FIRST COMPLIANCE REVIEW – ENGINEERING

**TEXACO REDEVELOPMENT AREA
PRELIMINARY & FINAL MAJOR SITE PLAN
AND MINOR SUBDIVISION APPLICATION**

**BLOCK 332, LOT 3; BLOCK 360, LOT 2;
BLOCK 390, LOTS 1 & 2; AND BLOCK 391, LOT 1
CITY OF BAYONNE, HUDSON COUNTY, NEW JERSEY**

March 2022

Figure 4 : Area of proposed private open space and potential future helipad.

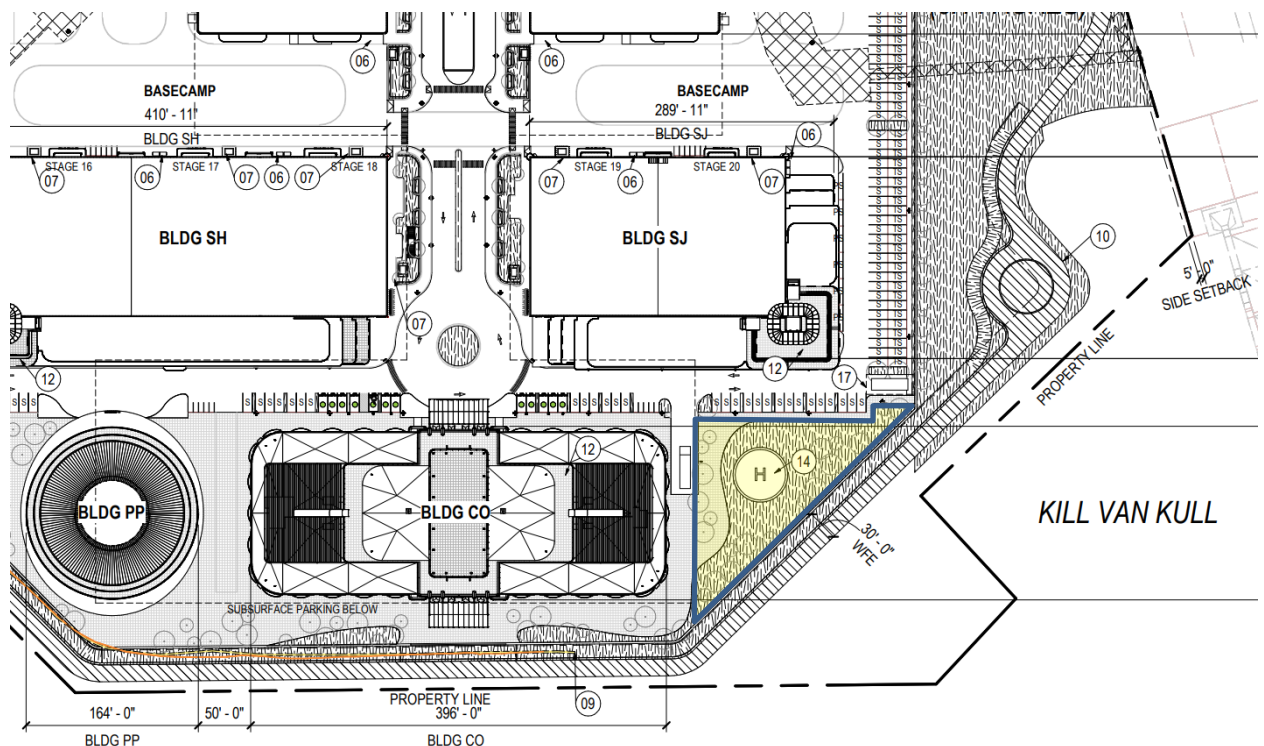
- The Applicant has reserved a proposed open space near the northeast corner of the Site for Studio (private) open space and a future helipad that will be elevated above the adjoining waterfront walkway (see Figure 3). The Applicant should consider revising the layout and retaining wall location to make this part of the public open space attached to the walkway.
